Docket Nos.: 52-025
52-026

ND-18-0374
10 CFR 50.90

**Southern Nuclear Operating Company
Vogtle Electric Generating Plant Units 3 and 4
Request for License Amendment:
Technical Specification Changes to Support Operability During Mode 5
Vacuum Fill Operations (LAR-18-009)**

Figure 1: Depiction of PRHR HX Inlet Line (Not to Scale)

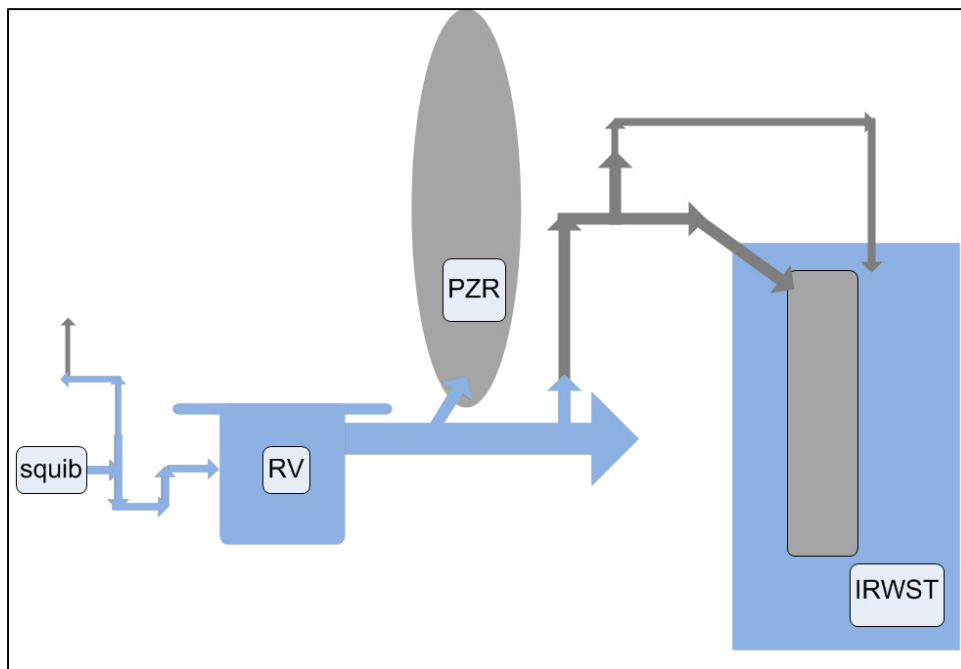
During RCS vacuum fill, the PRHR HX inlet line begins to fill along with the RCS. When pressurizer level reaches 20%, TS 3.5.5 requires the PRHR HX to be OPERABLE. However as shown in Table 1 and Figure 1, a pressurizer level of 20% is below the elevation of the high point water level sensor in the PRHR HX inlet line. As such, at that time the inlet line cannot be vented. Therefore, the PRHR HX inlet line noncondensable gas volume is out of limit, making

the PRHR HX inoperable due to failure of SR 3.5.4.3 (which is required per SR 3.5.5.1). When the RCS is water solid and returned to atmospheric conditions prior to concluding vacuum refill operations, the PRHR HX will be vented and restored to OPERABLE status.

Therefore, TS 3.5.5 SR 3.5.5.1 imposing the requirement to meet SR 3.5.4.3 unnecessarily precludes compliance with TS 3.5.5 once the RCS reaches 20% pressurizer level during vacuum refill. As such, SR 3.5.5.1 is proposed to be revised to account for RCS vacuum fill operations.

Changes to COL Appendix A (Plant-specific Technical Specification) TS 3.5.5 are proposed to add a Note to the Applicability which states "PRHR HX is not required to be OPERABLE in MODE 5 during RCS vacuum fill operations." In addition, UFSAR Subsection 19E.2.3.2.4 is revised to note that the PRHR HX does not provide decay heat removal during RCS vacuum fill operations. With these changes, the PRHR HX is not required to be OPERABLE during RCS vacuum fill.

- LCO 3.5.5 Applicability is revised to add a note "PRHR HX is not required to be OPERABLE in MODE 5 during RCS vacuum fill operations."

Figure 2: Depiction of IRWST Injection Line (Not to Scale)

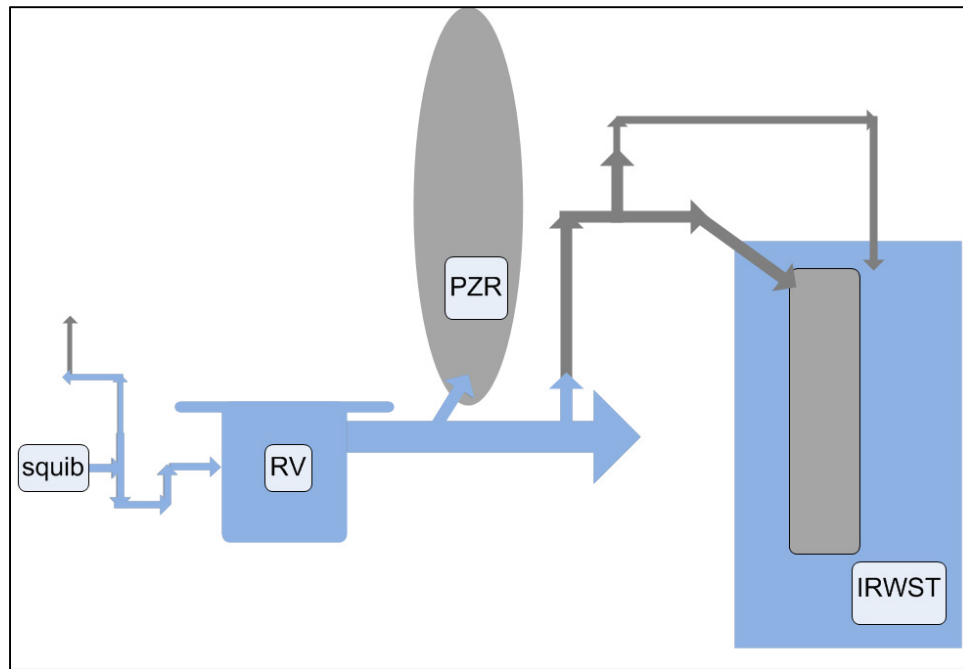
When vacuum refill conditions are established in MODE 5, the RCS level is at mid-loop, and the pressure at the high point level sensors may be less than the saturation pressure of expected RCS temperatures. As a result, the water in the IRWST injection high point vent lines will

vaporize the volume of water sufficiently to initiate an alarm which is primarily used to alert operators of noncondensable gas in the line (see Table 2 and Figure 2 for relative elevations). Therefore, the IRWST injection line noncondensable gas volume is out of limit, making the IRWST inoperable per failure of SR 3.5.6.3 (which is required per SR 3.5.7.1).

A gas void could form in the IRWST injection high point vent if dissolved gases were to come out of solution as pressure is reduced during vacuum refill. The size of the gas void is calculated to fill 53-63% of the IRWST injection high point vent piping depending on temperature. This will initiate an alarm; however, this volume would not penetrate into the main IRWST injection line and therefore would not interrupt IRWST injection flow. Therefore, the IRWST continues to be OPERABLE and meet its safety function.

Changes to COL Appendix A (Plant-specific Technical Specification) TS 3.5.7 are proposed to remove SR 3.5.6.3 applicability from SR 3.5.7.1 and add SR 3.5.6.3 applicability to new SR 3.5.7.2 with a Note that it is not required to be met during RCS vacuum fill operations.

- SR 3.5.7.1 is revised to invoke all SRs of TS 3.5.6, except SR 3.5.6.3.

- TS 3.5.7 is revised to add new SR 3.5.7.2 to invoke SR 3.5.6.3, with a Note that it is not required to be met during RCS vacuum fill.
